PLANS AND DOCUMENTS referred to in the PDA DEVELOPMENT APPROVAL

Approval no: DEV2025/FLA/4175
Date: 06 February 2026

PROJECT
HERCULES STREET

SITE ADDRESS
19 HERCULES ST HAMILTON, BRISBANE QLD 4000

PROJECT	
HERCULES STREET	
SITE ADDRESS	
19 HERCULES ST HAMILTON, BRISBANE QLD 4000	
JOB NO	
1944	
CHECKED	DRAWN
AA	RL
DATE	SCALE
21/12/2025	1:200 @ A1
	A3@50%
PROJECT STATUS	
DEVELOPMENT APPLICATION	
DRAWING TITLE	
EAST ELEVATION

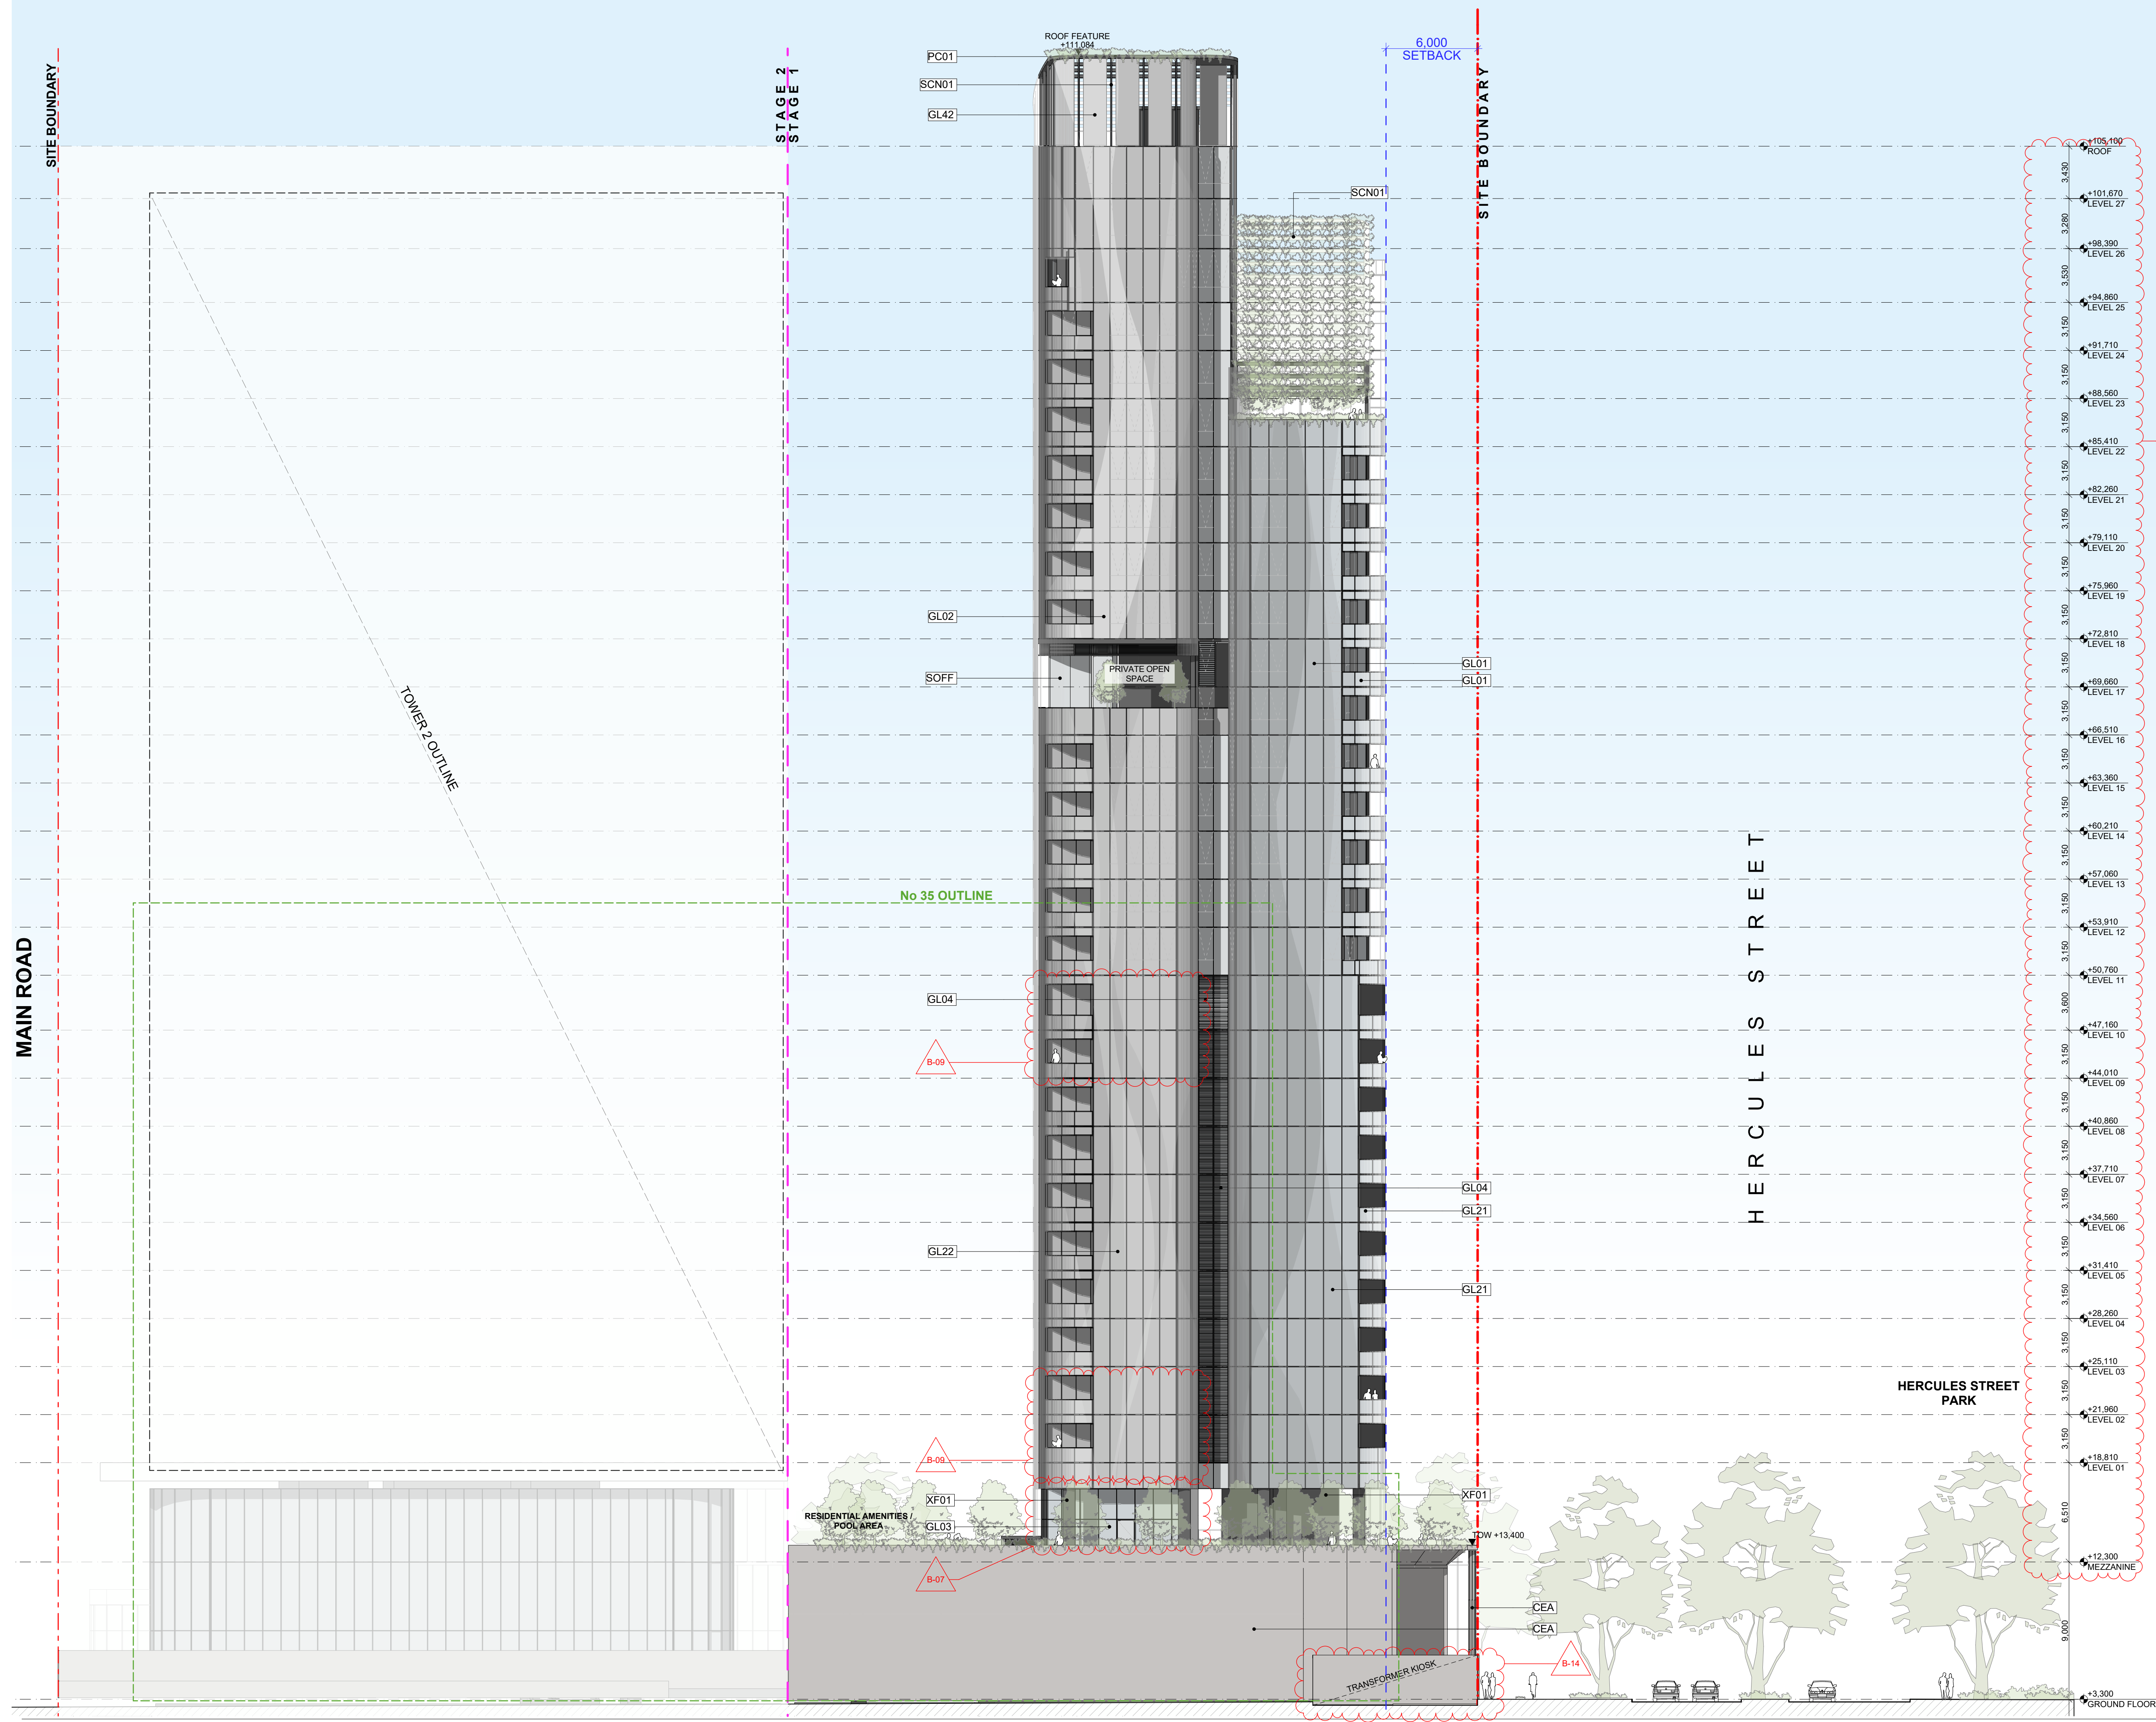
CHANGE	DESCRIPTION
B-07	INTERNAL LAYOUT OPTIMIZED TO INTEGRATE HOTEL AMENITIES
B-09	CHANGE OF USE TO HOTEL FROM L1-L10 (SKY GARDEN CONVERTED TO HOTEL USE)
B-13	FLOOR TO FLOOR HEIGHT CHANGES
B-14	TRANSFORMER ENCLOSURE AMENDED FOR SERVICES

SOUTH ELEVATION

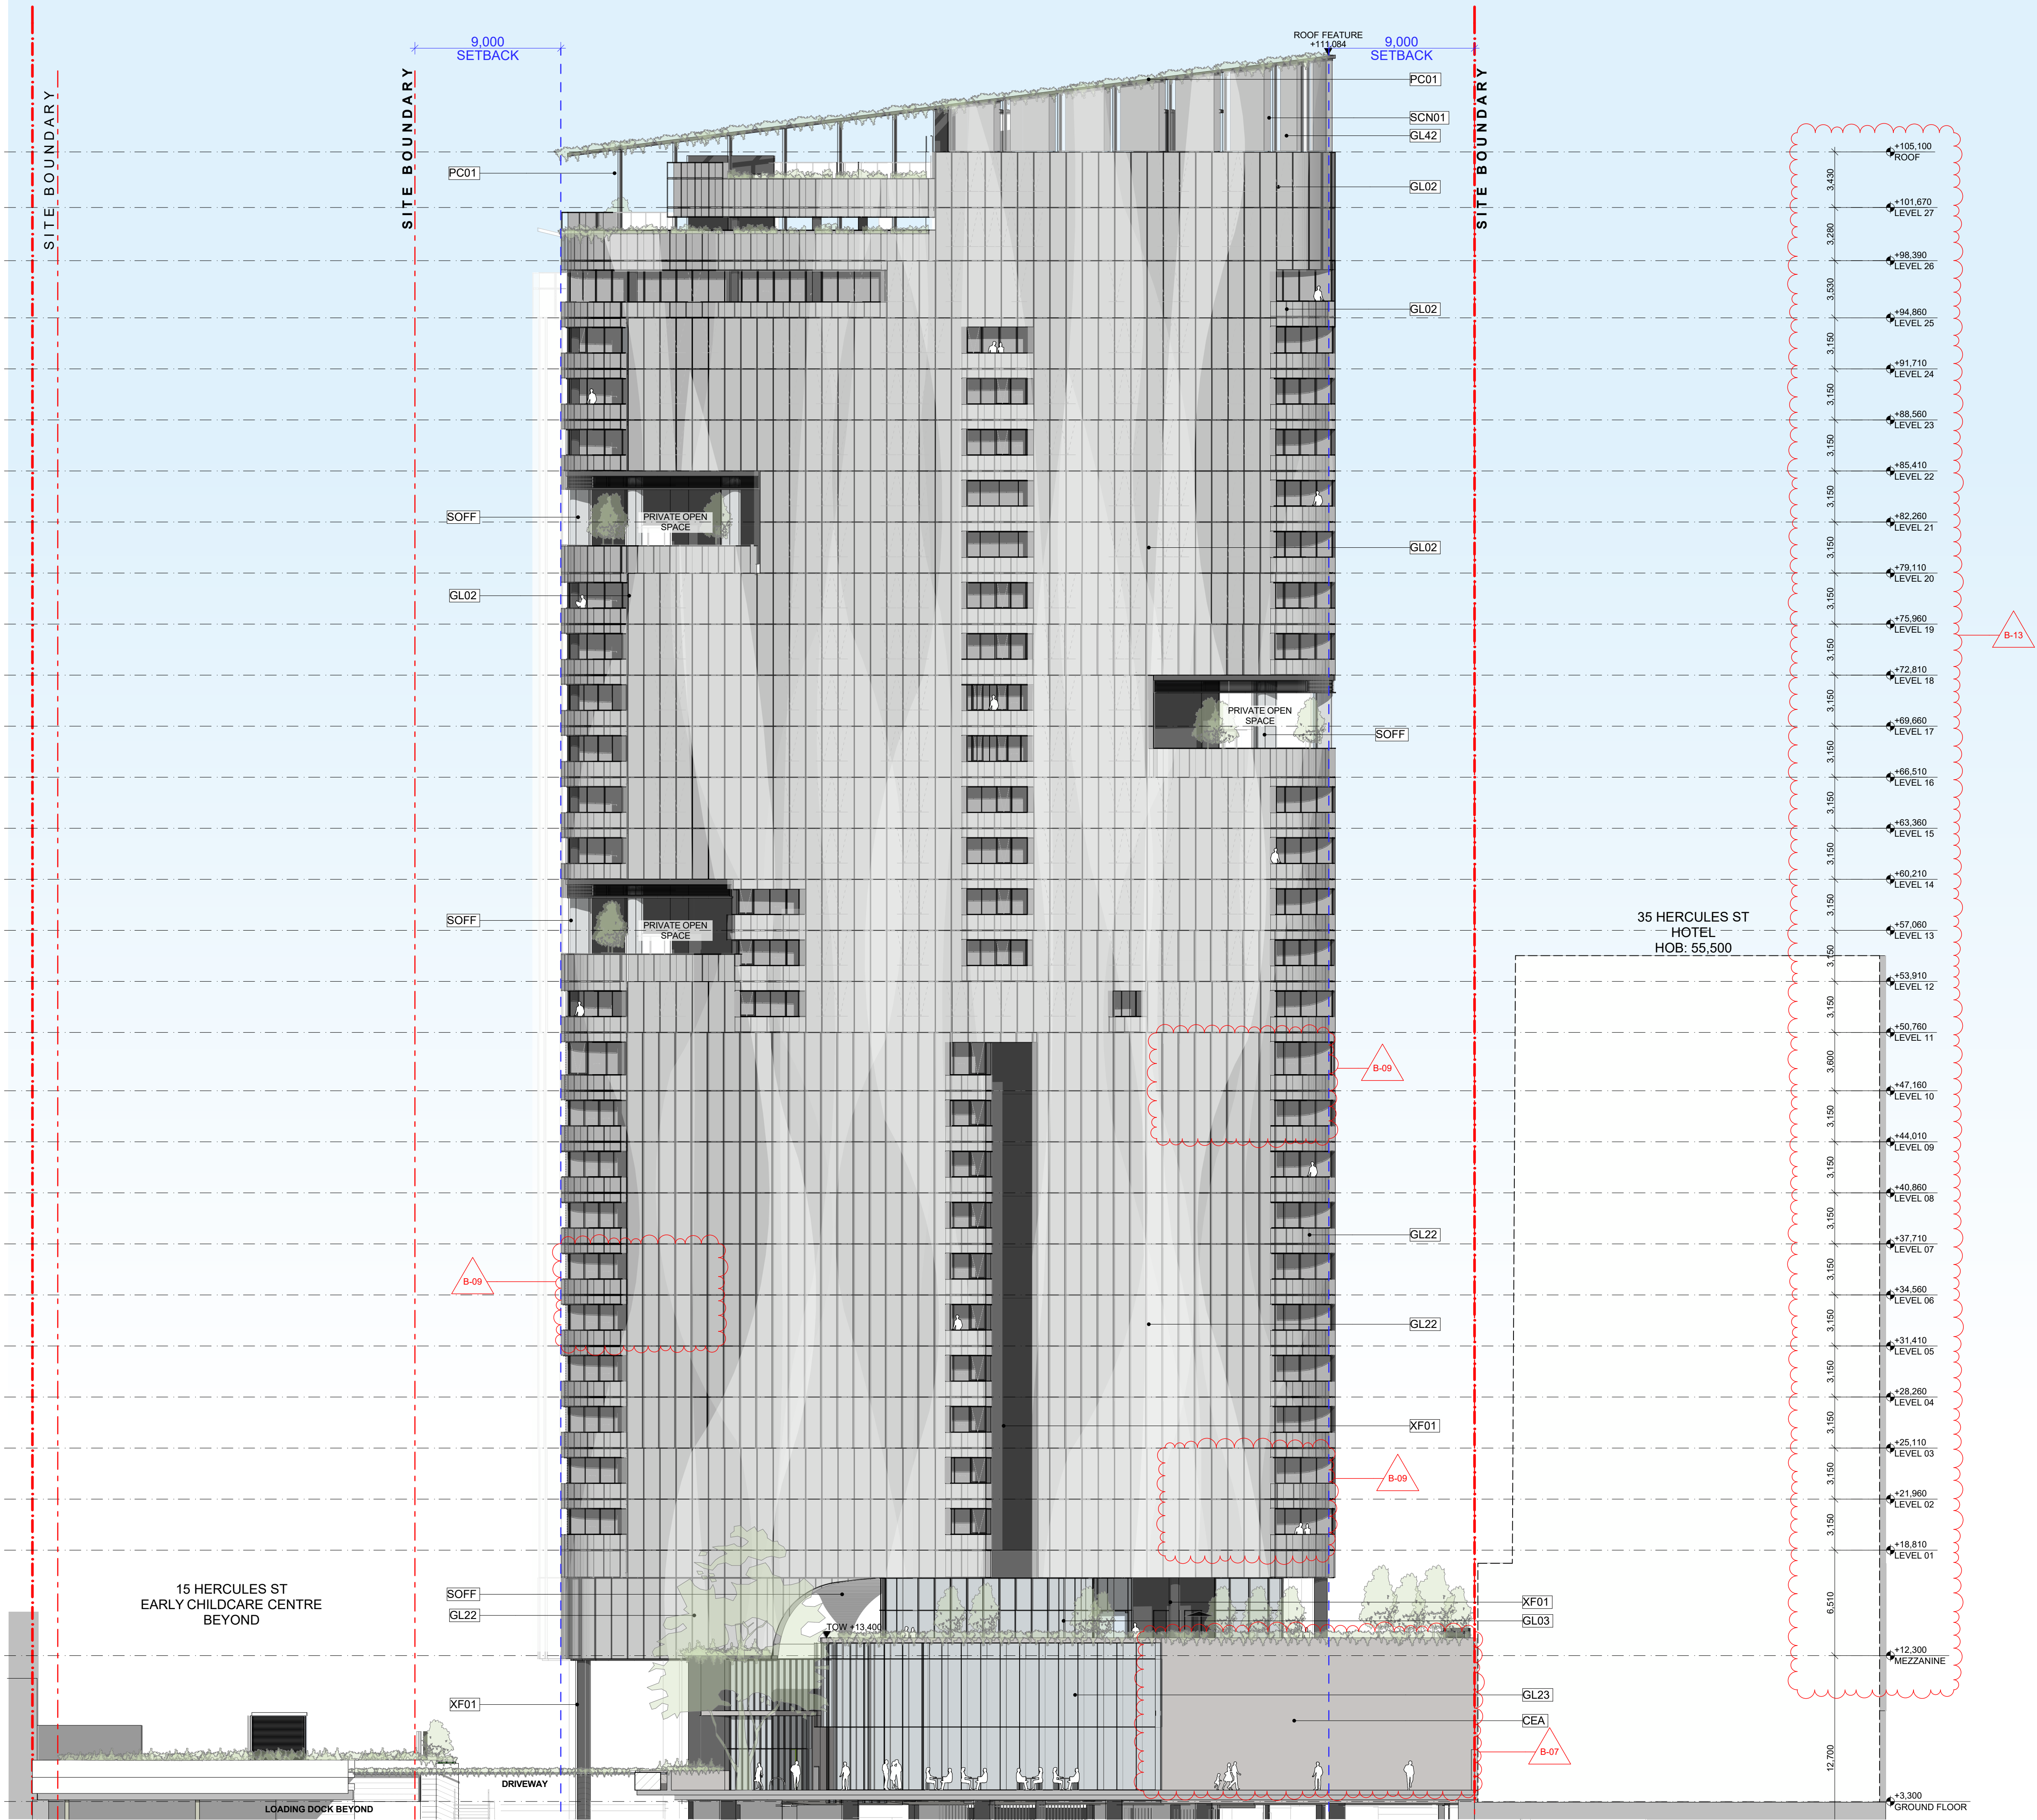
CHANGE	DESCRIPTION
B-07	INTERNAL LAYOUT OPTIMIZED TO INTEGRATE HOTEL AMENITIES
B-09	CHANGE OF USE TO HOTEL FROM L1-L10 (SKY GARDEN CONVERTED TO HOTEL USE)
B-13	FLOOR TO FLOOR HEIGHT CHANGES

SECTION DD

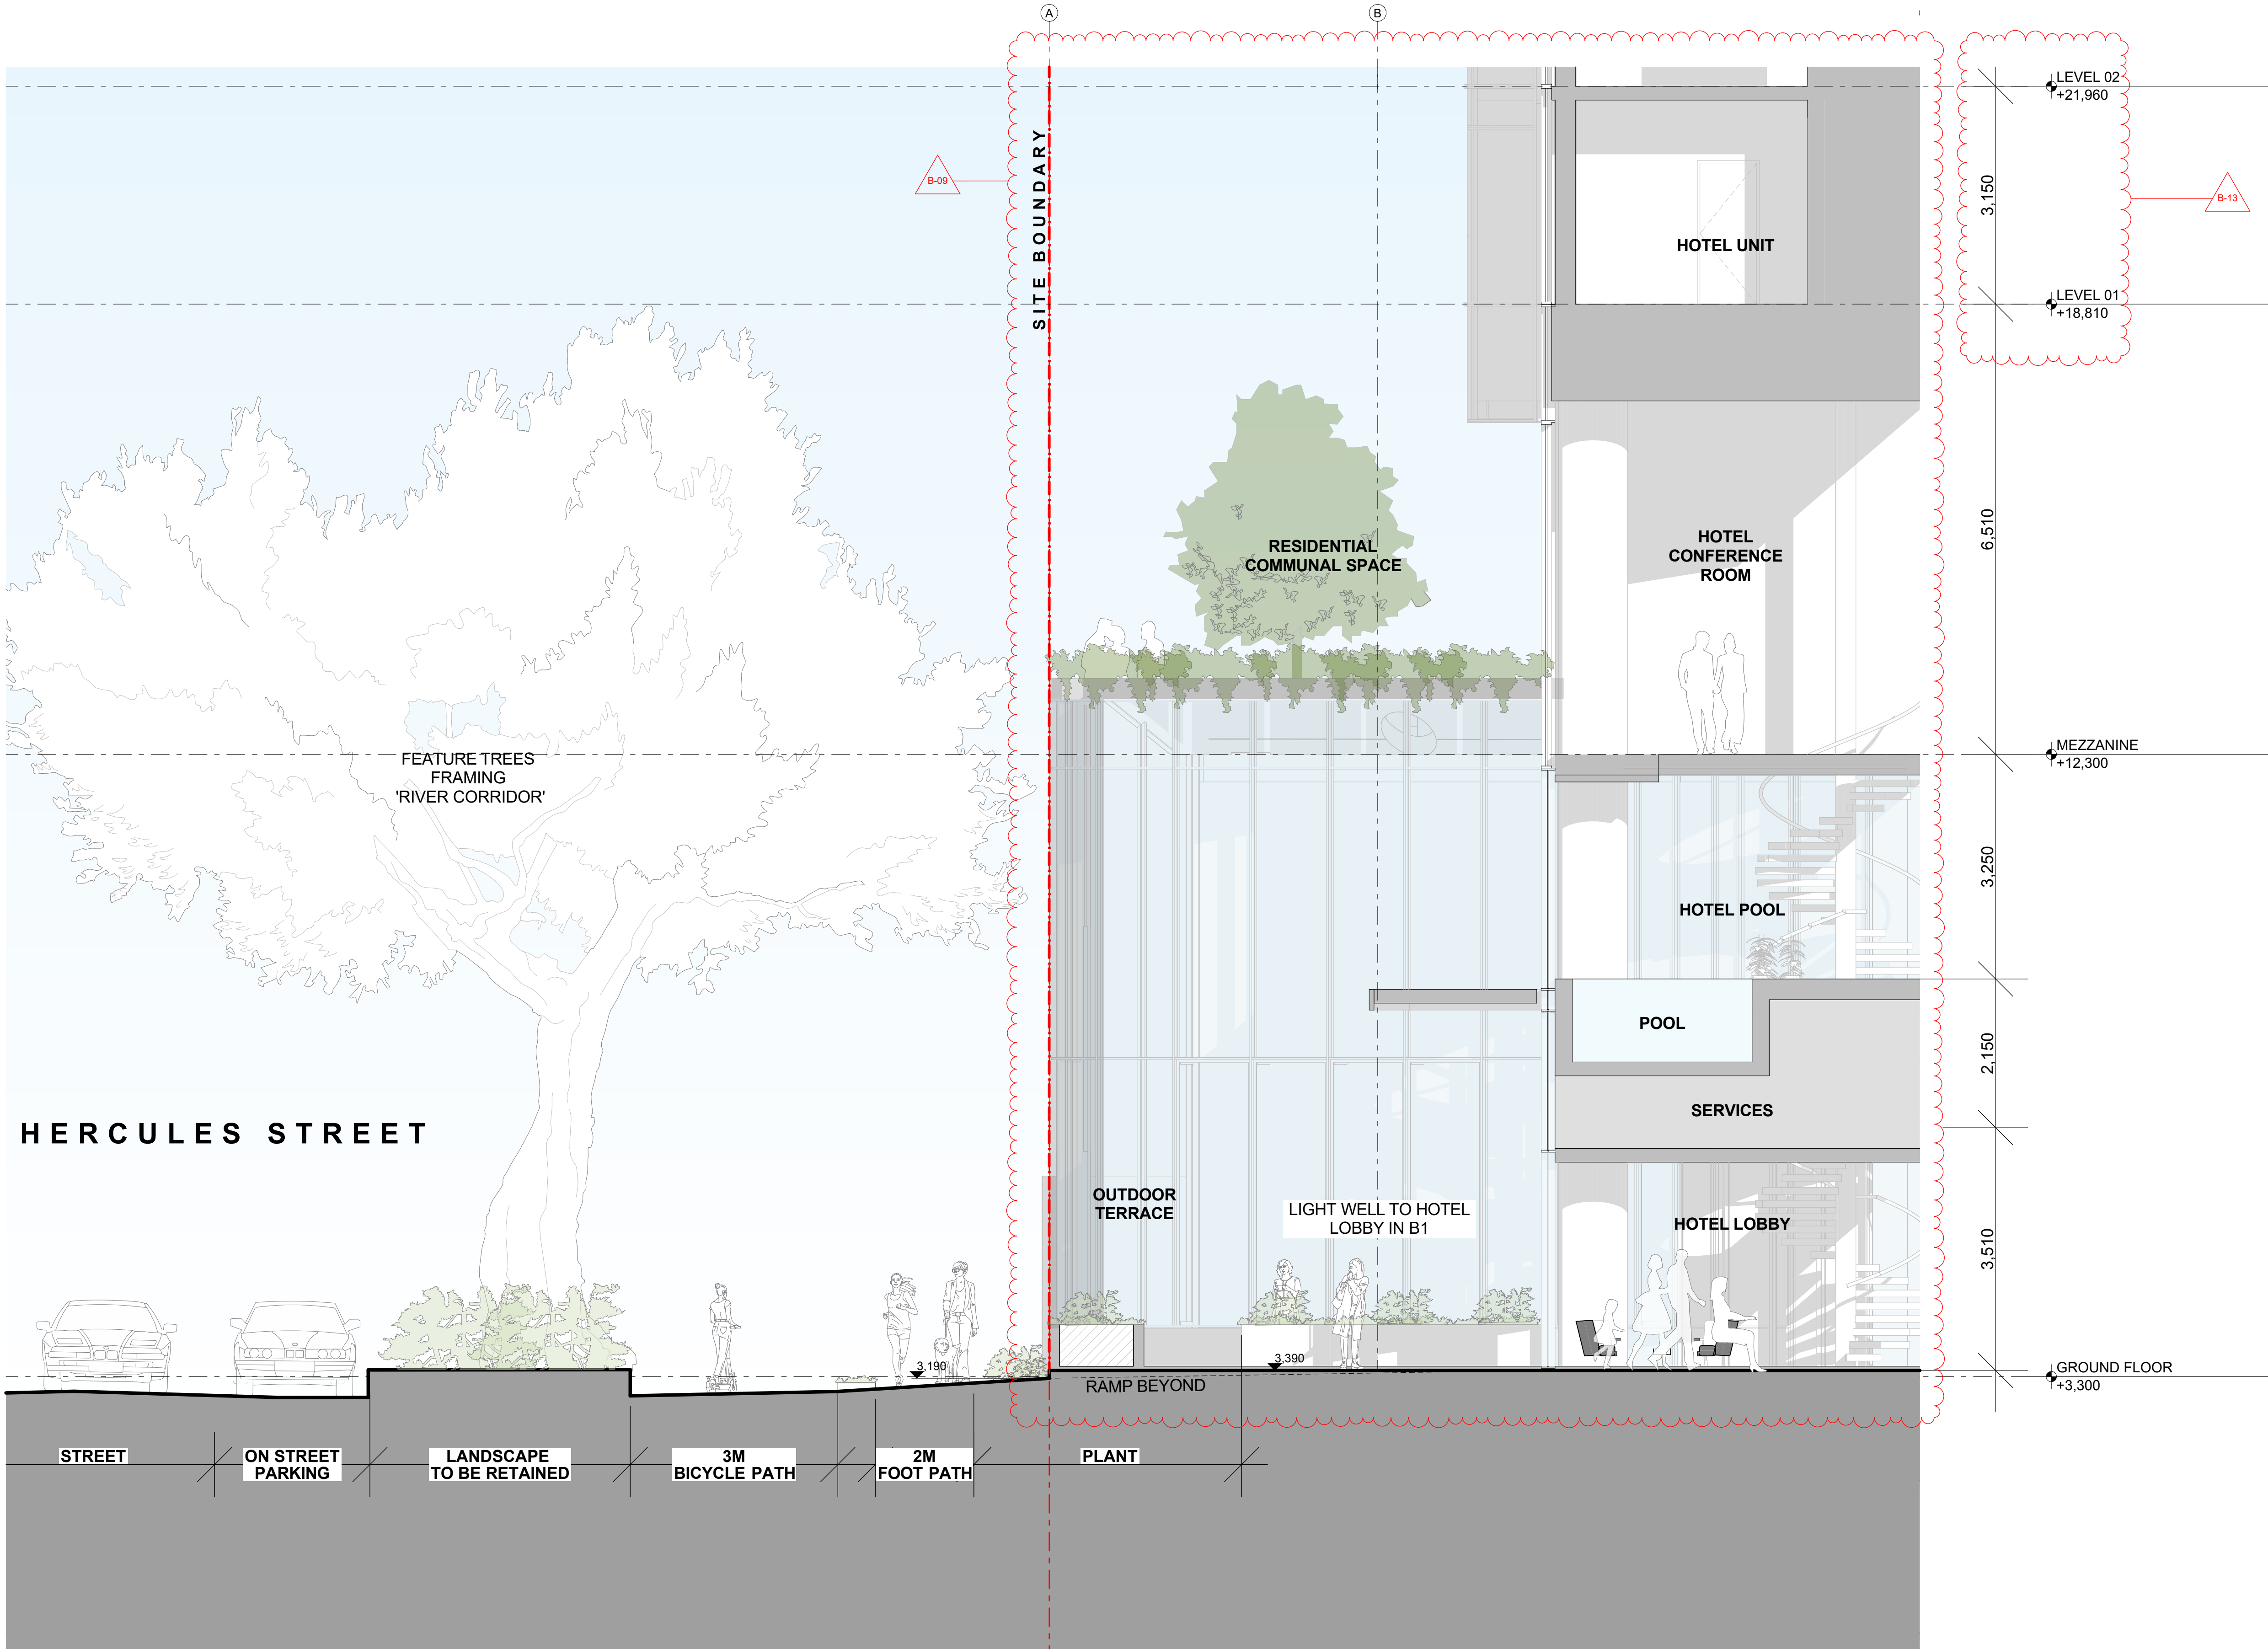
CHANGE	DESCRIPTION
B-09	CHANGE OF USE TO HOTEL FROM L1-L10 (SKY GARDEN CONVERTED TO HOTEL USE)
B-13	FLOOR TO FLOOR HEIGHT CHANGES
